MULTI Air Conditioner

Publication No: PWE09050 Publication Date: June 2009

Technical Information

Title: Handling the return air temperature sensor (TH1) according to the return duct structure

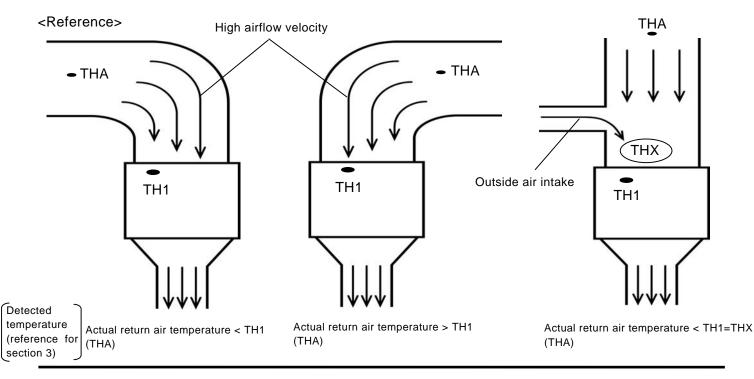
When a bend in the return duct is very close to the unit connected to the duct, actual return air temperature is different from the return air temperature detected by the sensor on the unit (TH1).

Since a bend in the return duct causes an uneven airflow distribution, the temperature difference occurs between actual return air temperature and the return air temperature detected by the sensor when the return air temperature is measured at a single point.

When the unit has a straight return duct or no return duct, there is no temperature difference between actual return air temperature and the return air temperature detected by the sensor.

If there is a problem with room temperature control, apply the following remedies.

1) When using a remote controller with a temperature sensor, AND installing the controller in a location where an average room temperature can be detected,

Use the sensor on the remote controller to control the room temperature.

- 2) Other than section 1) above
 Use a Remote Sensor (sold separately) (PAC-SE41TS-E). (Refer to the attached document.)
 1. Install this sensor inside the room.
 - 2. Install this sensor in a location where an actual return air temperature can be detected inside the duct.
- 4. Additional notes
